TRANS/WP.29/GRRF/2002/17/Rev.3
9 July 2004

PROPOSAL FOR DRAFT AMENDMENT TO REGULATION No. 64
(Temporary use spare wheels/tyres)

Revision 3

Transmitted by the Expert from the United Kingdom

Paragraph 5.1.4.1., amend to read (the diagram is not amended):

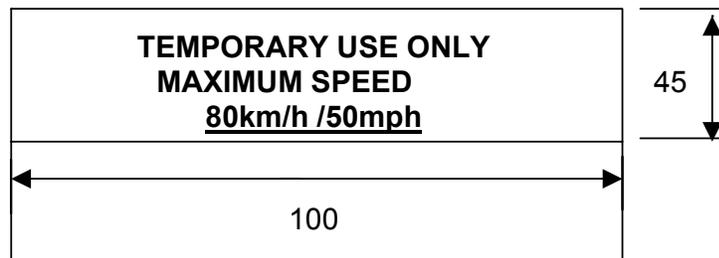
"5.1.4.1. An 80 km/h maximum speed warning symbol arranged in accordance with the diagram below, shall be permanently displayed on the outer face of the wheel in a prominent position.

In the case of vehicles intended to be sold in countries using imperial units of measurement, an additional warning symbol, identical to that described above, with the exception that the figure "80" shall be replaced by "50" and the wording "km/h" by "mph", shall be permanently displayed on the outer face of the wheel in a prominent position.

Alternatively a single warning symbol arranged in accordance with the diagram below, shall be permanently displayed on the outer face of the wheel in a prominent position.

Upper case letters shall be at least 5 mm high and the numbers "80" and "50" shall be at least 20 mm high with the elements that make up each character of the number at least 3 mm line thickness. Lower case text shall be at least have a line height of 5 mm. All text shall be enclosed in a border and be on a background of contrasting colour.

The requirements of this paragraph shall not apply to a temporary use spare wheel and tyre unit that includes or comprises [either] a run-flat tyre, [or a uni-directional]."
